To the Lafayette City Council

May 13, 2024

Re: Lafayette Reservoir Outlet Tower – EBMUD Seismic Evaluation and Retrofit Studies:
Follow-up to April 23rd online meeting between EBMUD, City of Lafayette
representatives and the Citizens Technical Advisory Committee

Figure 1 – Side-by-Side Overlay of Tower Shortening Retrofit Option (right) Proposed by EBMUD, Compared to As-Built Tower Height
(Overlay by Committee using EBMUD-provided images)

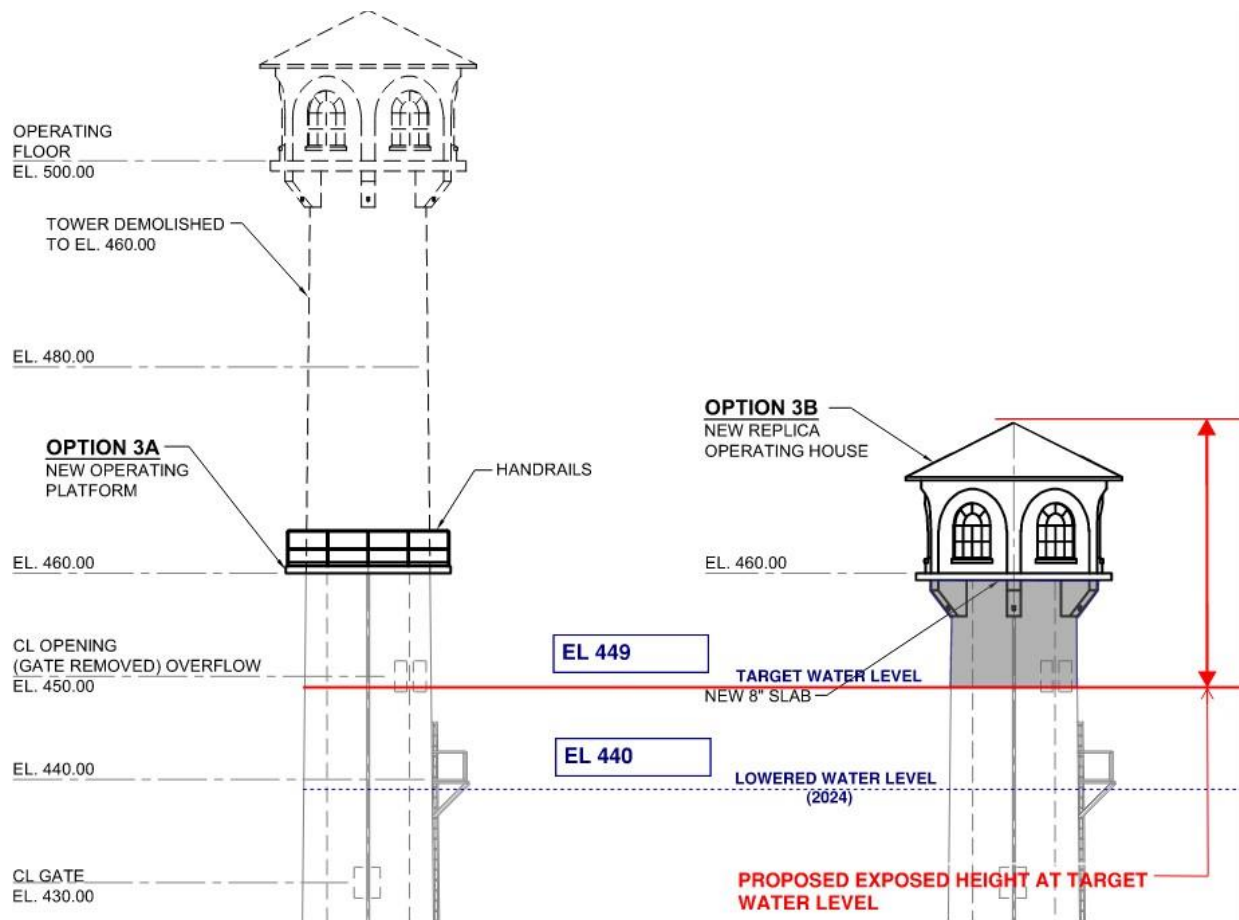
With reference to *Figure 1* below, EBMUD is proposing to shorten the Lafayette Reservoir Outlet Tower ("Tower") by approximately 40 feet as a seismic retrofit measure. To date, EBMUD has defended their proposal to remove this significant portion of the visually exposed height of the Tower by claiming it to be both the safest and most cost-effective solution for the ratepayers.

Based on extensive review of EBMUD's seismic analysis and conceptual design documentation, it is the consensus opinion of the Committee members that EBMUD's proposed shortening of the Tower would *increase* the seismic risk for the downstream residents of Lafayette in a major earthquake, rather than lessening the risk.

The basic idea behind EBMUD's scheme is that decreasing the height of the Tower would reduce the seismic effects on the Tower by eliminating a significant amount of its seismic inertial mass. While shortening of the Tower would reduce "bending" forces in the Tower, doing so would cause the Tower to *shake more violently*. This exacerbated shaking would significantly increase the more pernicious *lateral shear forces* near the base of the Tower. In the Committee's opinion, the resulting intensification of lateral shear forces near the base of the Tower would increase the seismic hazard to the entire Tower structure, and consequently to the emergency outlet system of the reservoir.

Figure 2 – Dynamic Effects of Tower Shortening

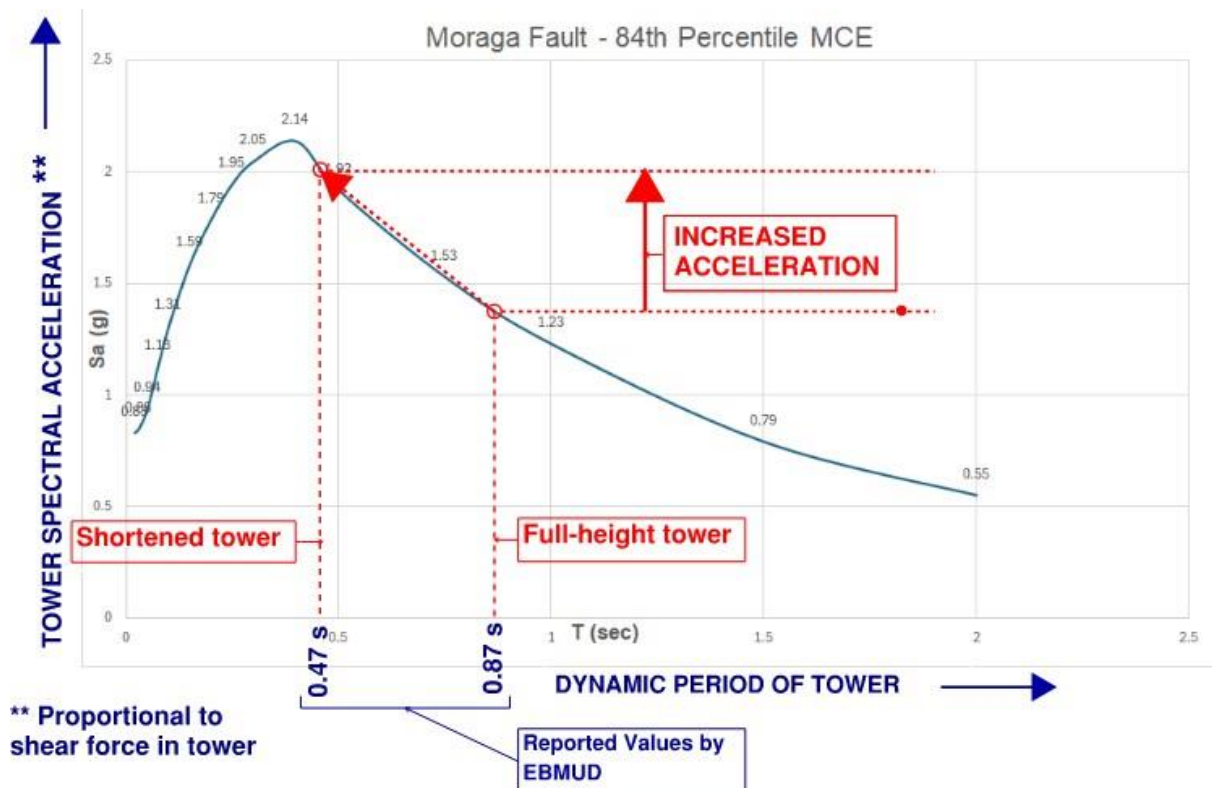
1. EBMUD's own analysis shows that shortening the Tower would change its dynamic response by shortening its vibration "period" (that is, the interval of time over which the Tower sways back and forth once) to a range where the Tower would respond *more violently* to earthquake shaking, which will actually *increase* the critical shear forces on the Tower.

Structural engineers who practice in the field of seismic design sometimes refer to the above-described phenomenon as "climbing the spectrum." (Refer to *Figure 2* below for illustration of this effect). Based on results of the evaluation of the Tower shortening scheme by EBMUD's engineering consultants, the seismic spectral response of the Tower is anticipated to shift to very near the peak (or worst possible) intensity of earthquake ground motion for the criterion-level earthquake spectrum that EBMUD's seismic evaluation is based upon.

In simple terms, the shortened *Tower would be expected to shake harder* than the full-height Tower. By EBMUD's own calculation, the fundamental dynamic period of the shortened Tower retrofit would be reduced to about 55 percent of that for the full-height Tower, which would result in a spectral acceleration in the Tower itself that is about 45 percent higher than for the full-height Tower. This more intense shaking of a shortened Tower would correspond to about a 13 percent increase in the seismic shear at the Tower base, according to EBMUD documentation.
